REPORT
OF THE
OPERATIONAL SAFETY REVIEW TEAM
(OSART)
MISSION
TO THE
SEQUOYAH
NUCLEAR POWER PLANT
UNITED STATES OF AMERICA

14 – 31 AUGUST 2017

DIVISION OF NUCLEAR INSTALLATION SAFETY
OPERATIONAL SAFETY REVIEW MISSION
IAEA-NSNI/OSART/195/2017

Fig 1. Snapshot of a section of the plant’s Emergency Management Guideline (EMG) flowchart

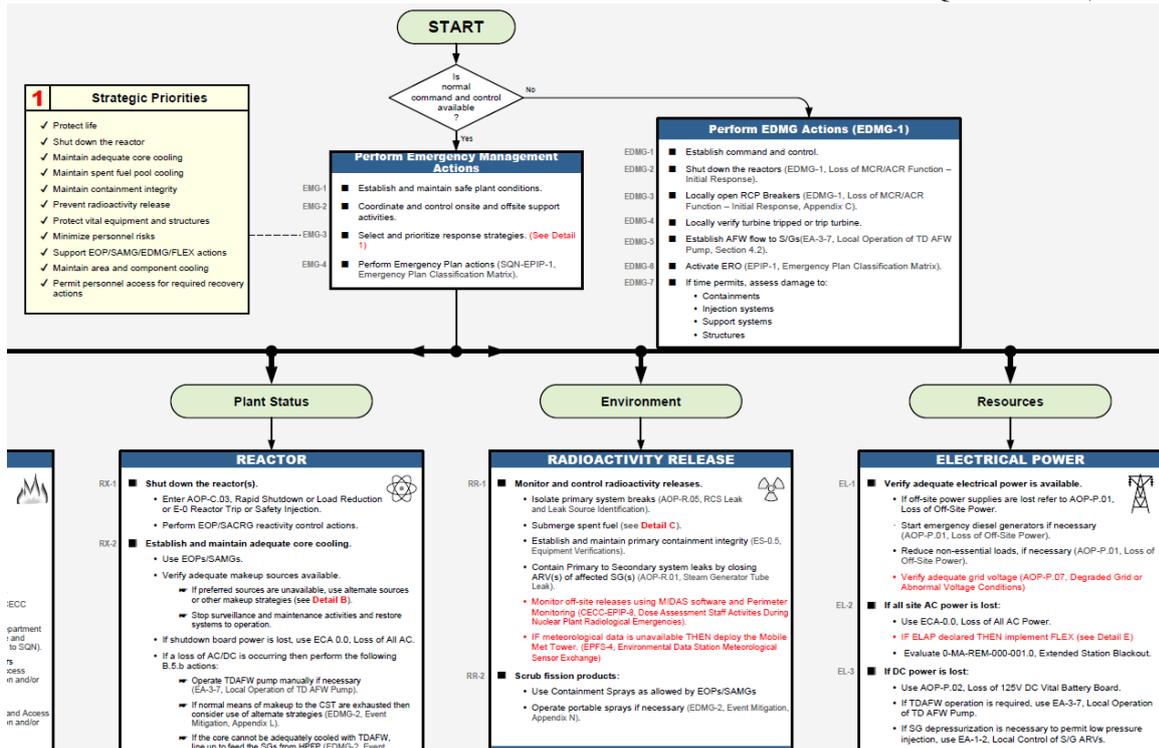
The plant has now developed an overall Emergency Management Guideline (EMG) flowchart, which provides a comprehensive overview of all strategies. It provides guidelines and other relevant documents for coping with extreme events or extensive damage to plant components, to re-establish a command structure, and to perform critical emergency support functions. The structured EMG flowchart allows responsible decision makers (Site Emergency Director or Senior Operations on Shift or other Senior Operations Personnel) to take the right decisions under various plant conditions that do not allow for more detailed planning in advance. This structured EMG flow chart has been presented and discussed within PWROG recently and implementation by the other plants of the PWROG is intended.

The team recognized this as a good practice.
